# WATER PLANS

FOR  
**TOWNHOMES AT WESTERN**

# SANITARY SEWER PLANS FOR TOWNHOMES AT WESTERN

# UTILITY SERVICE PLAN FOR TOWNHOMES AT JETWING COLORADO SPRINGS, COLORADO

UTILITY SERVICE PLAN PLAN SHEET

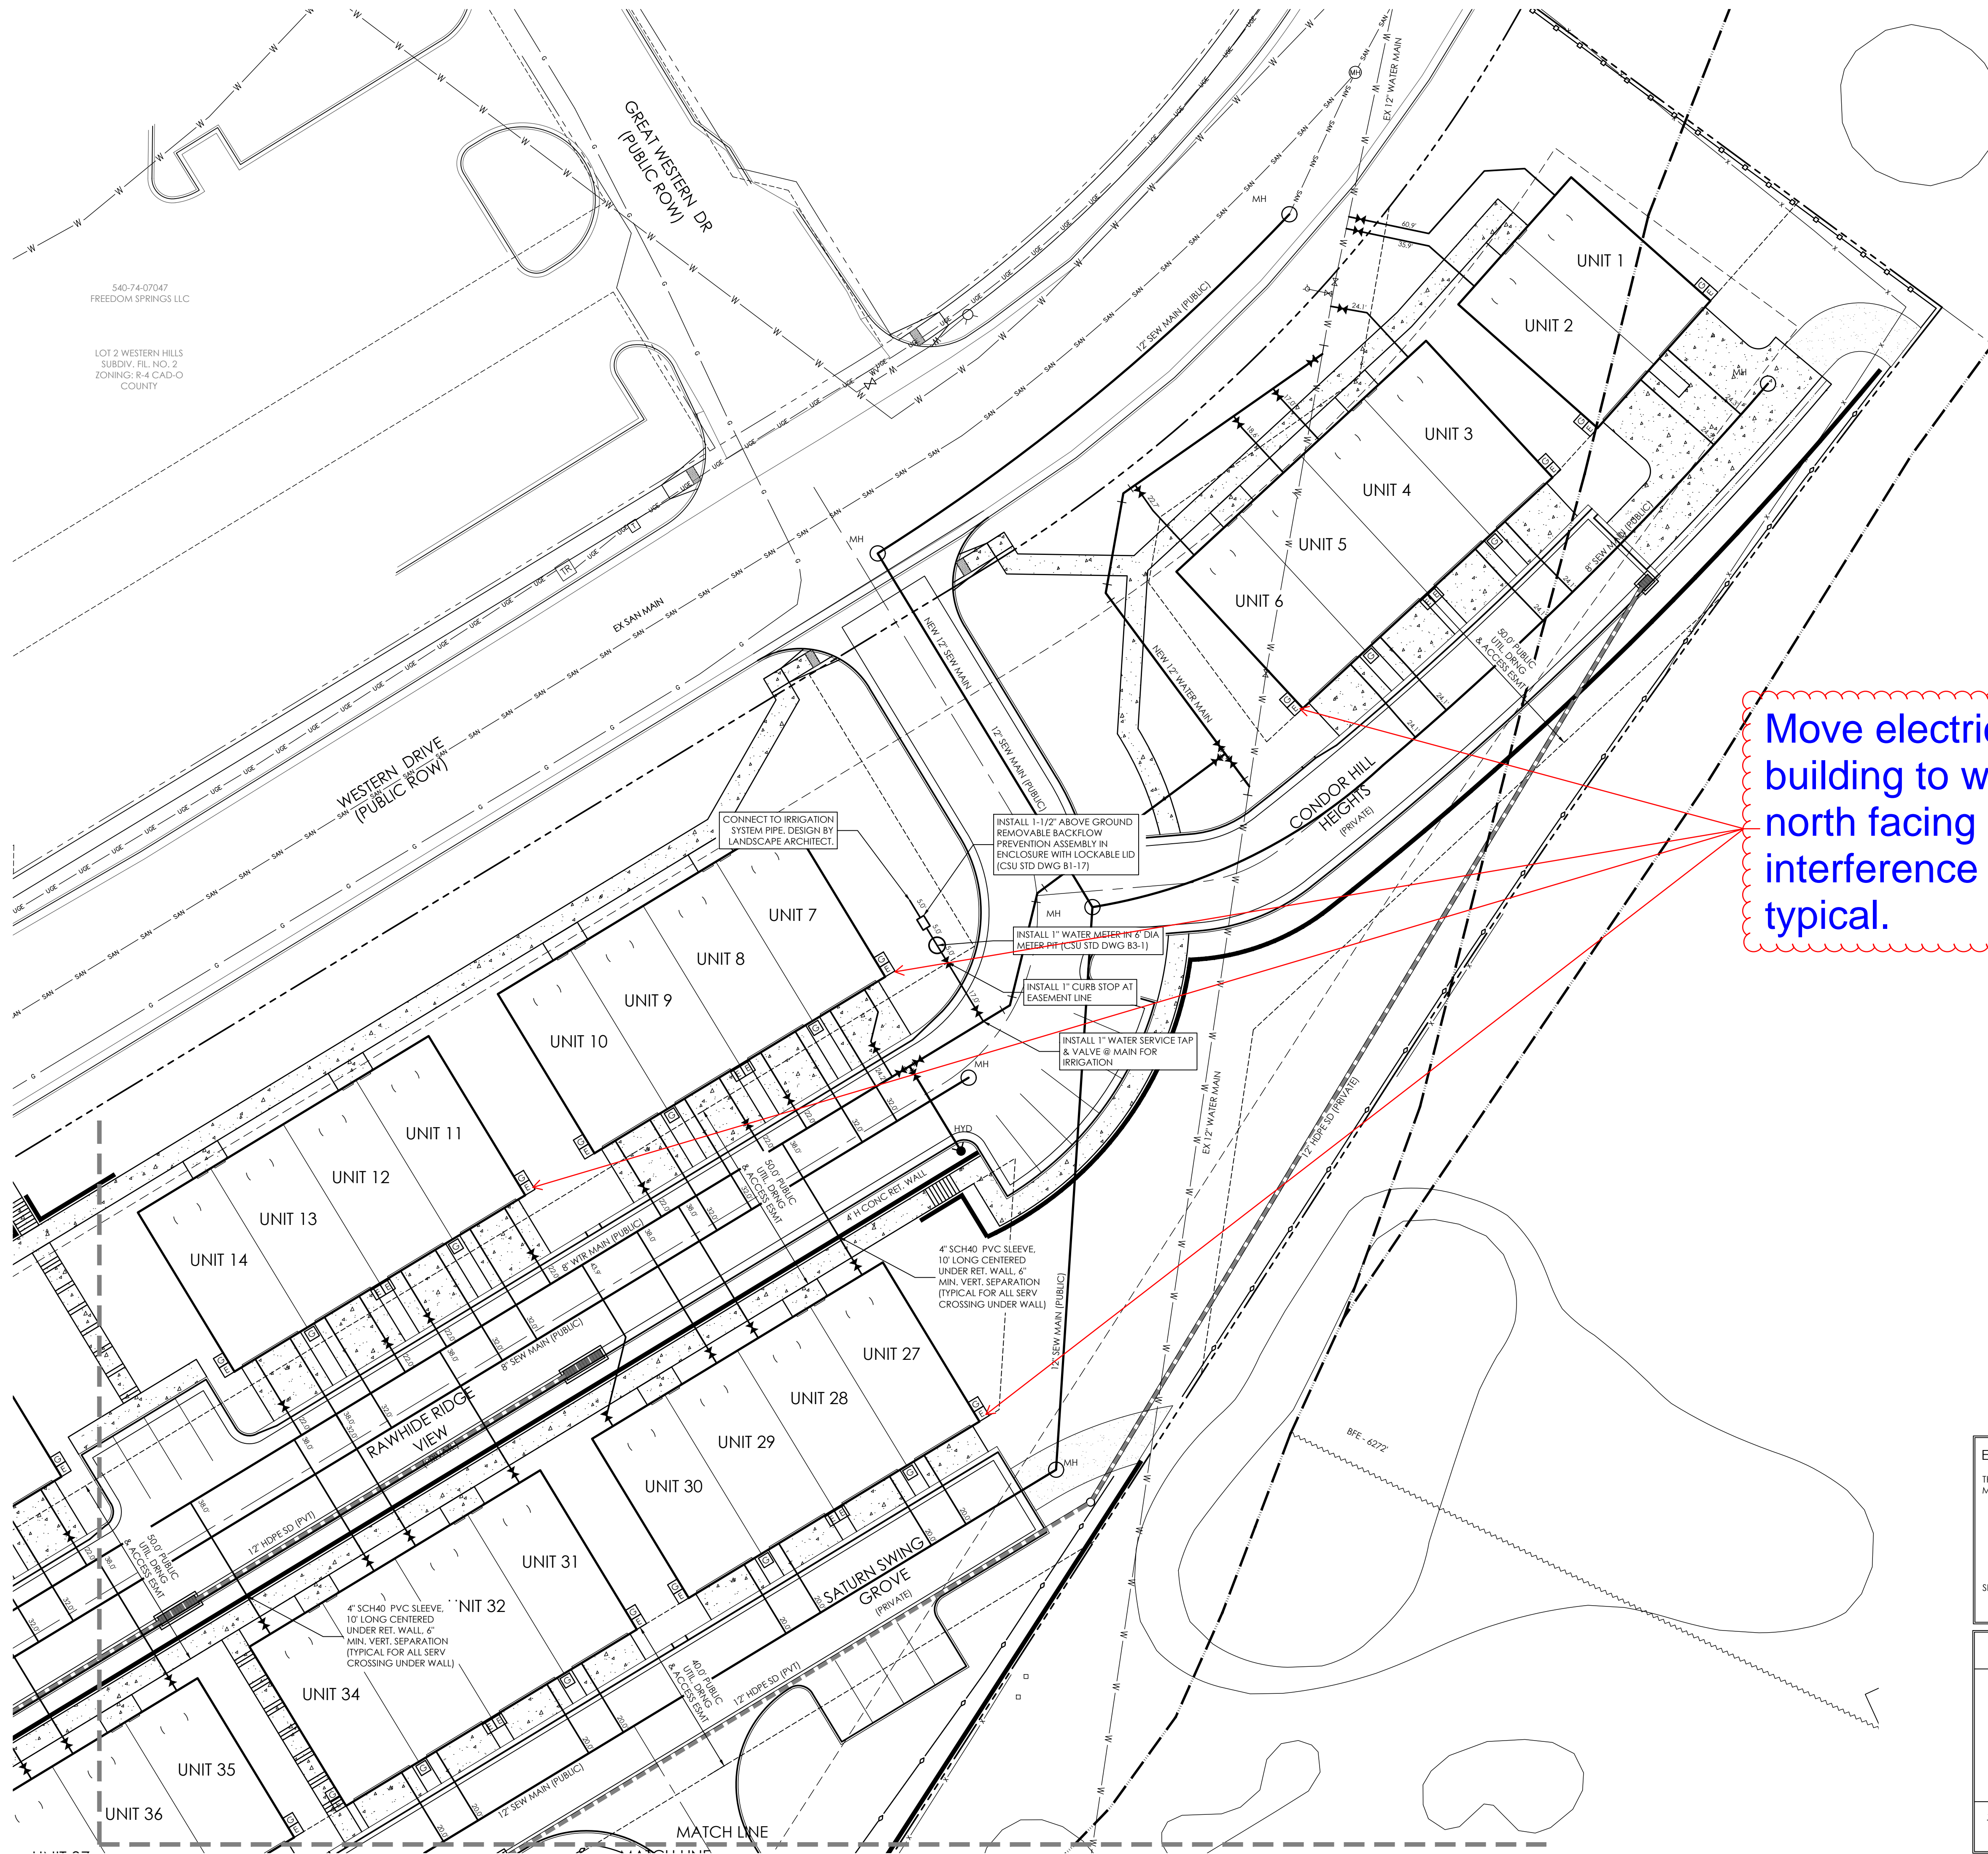
Move electric connection to building to within 5-feet of the north facing wall to ensure no interference with window wells, typical.

**UTILITY SERVICE  
PLAN  
PLAN SHEET**

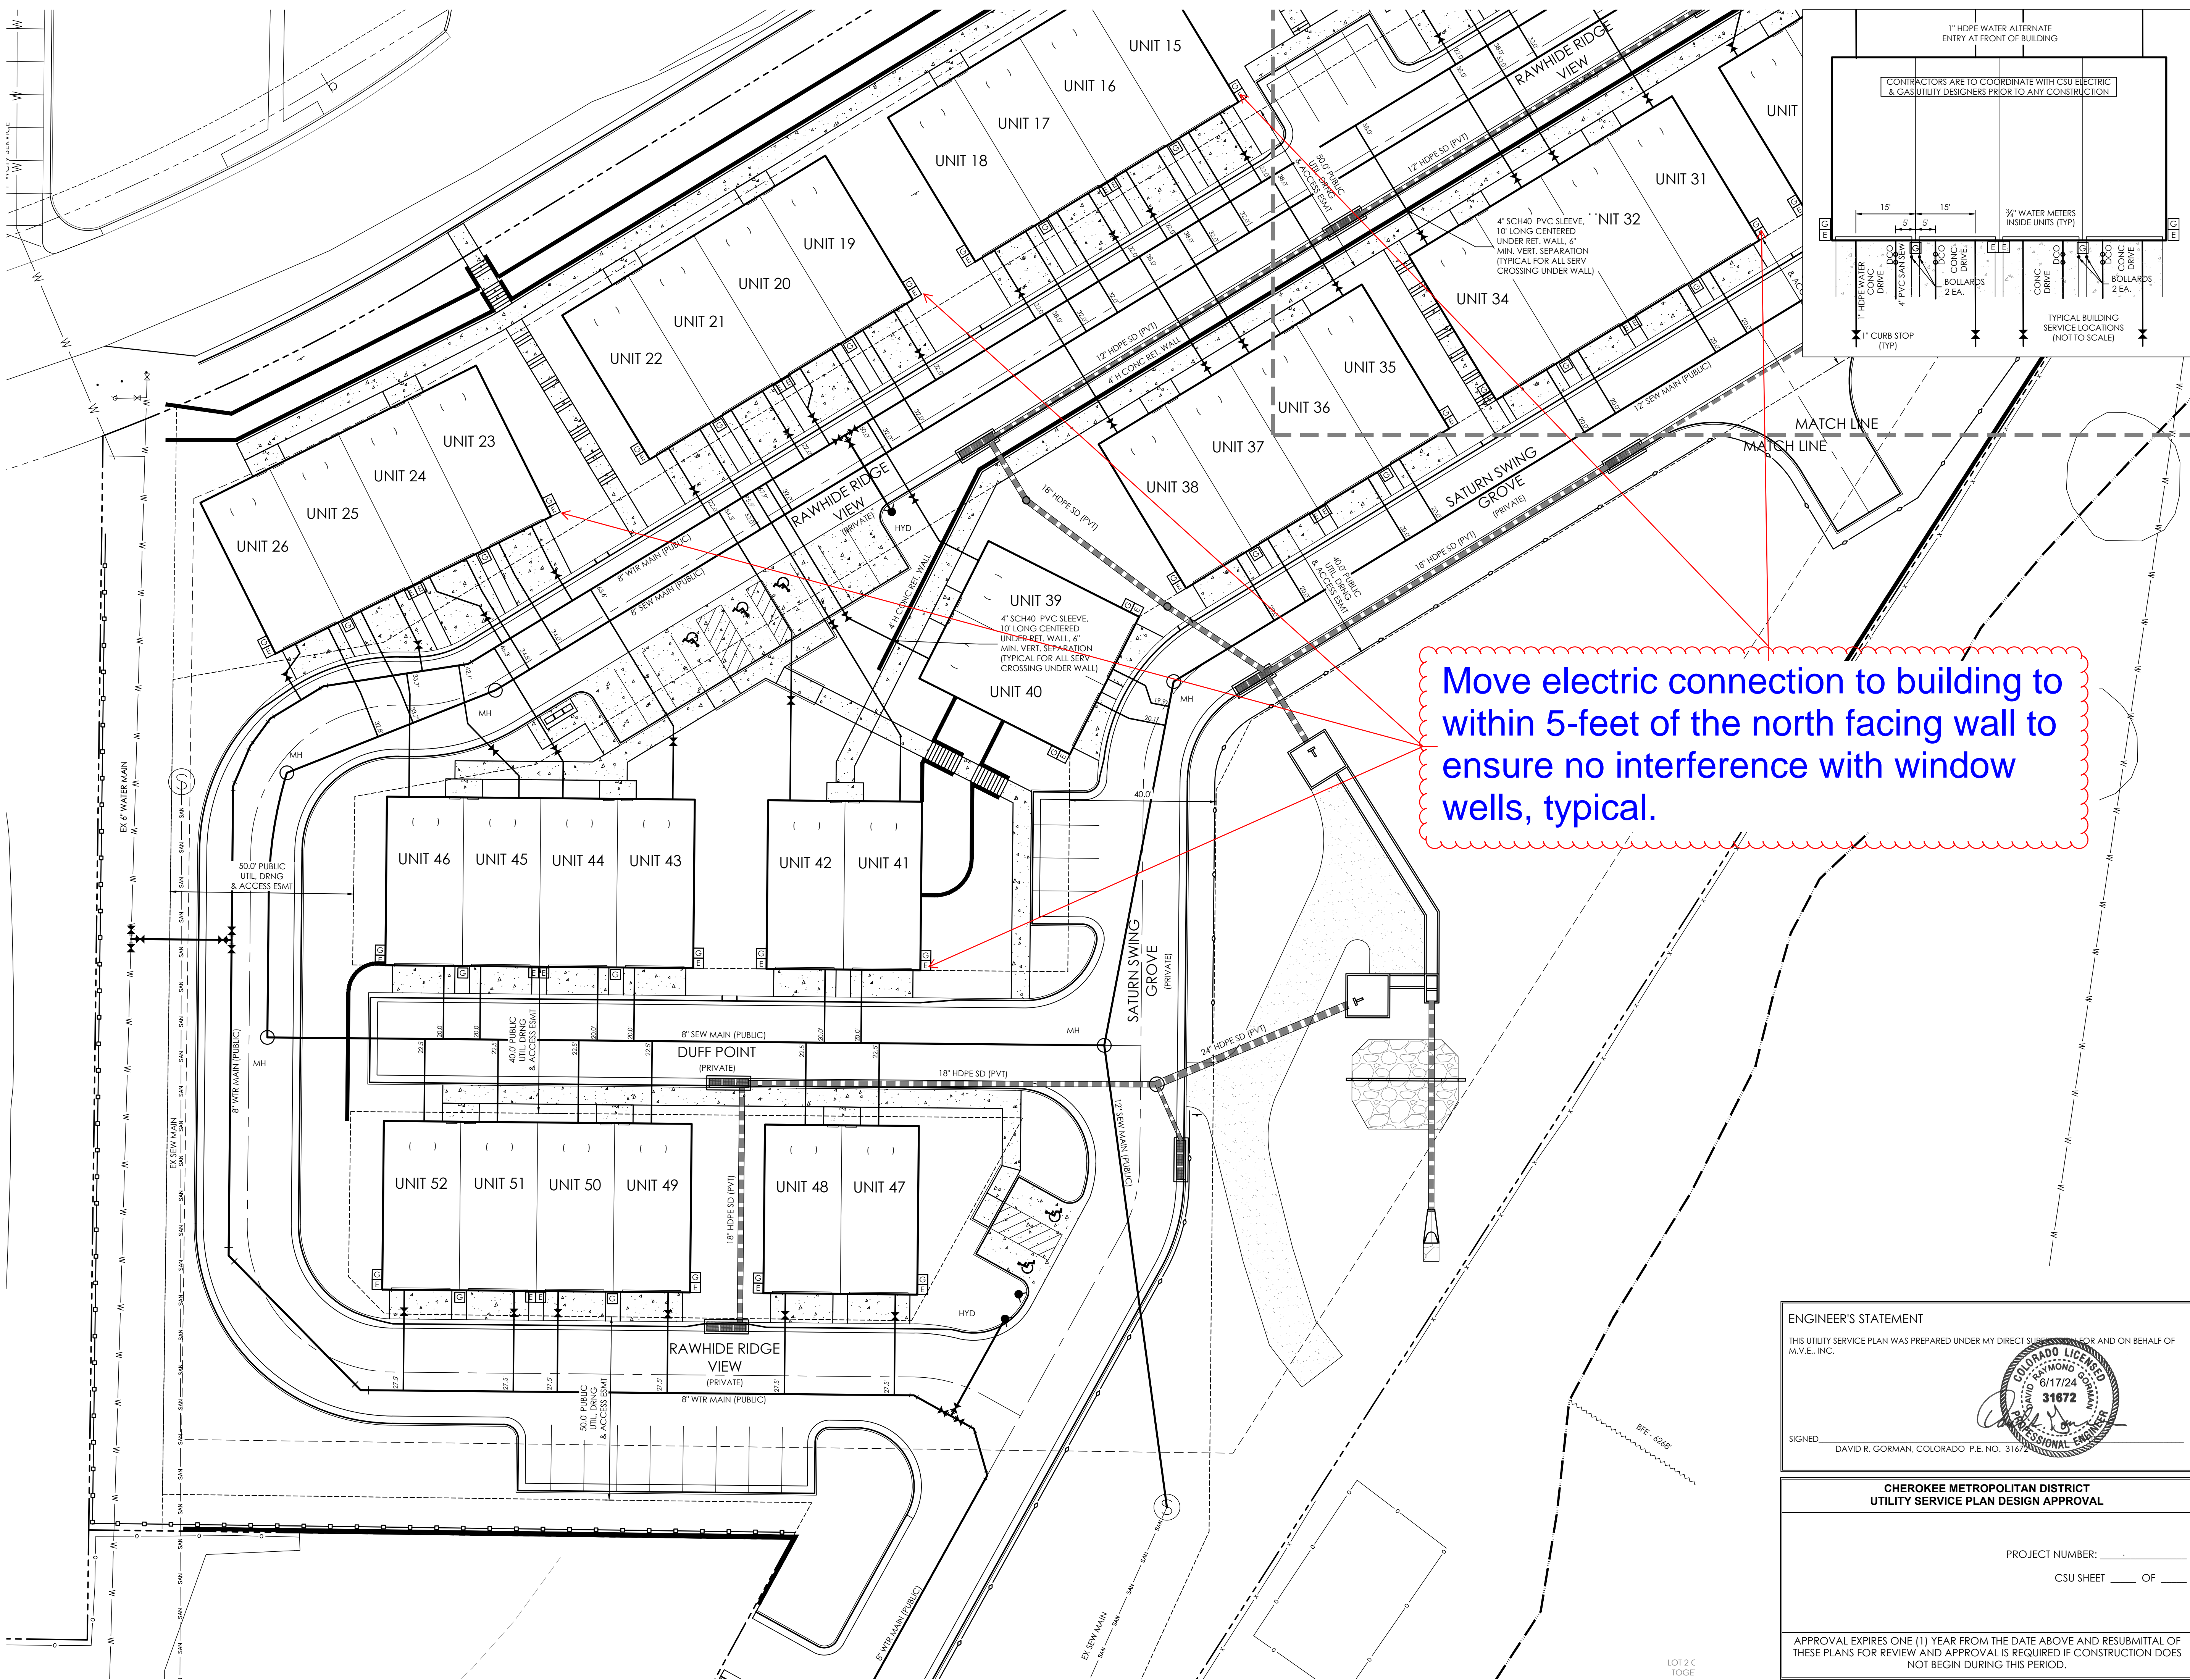
Move electric connection to building to within 5-feet of the north facing wall to ensure no interference with window wells, typical.
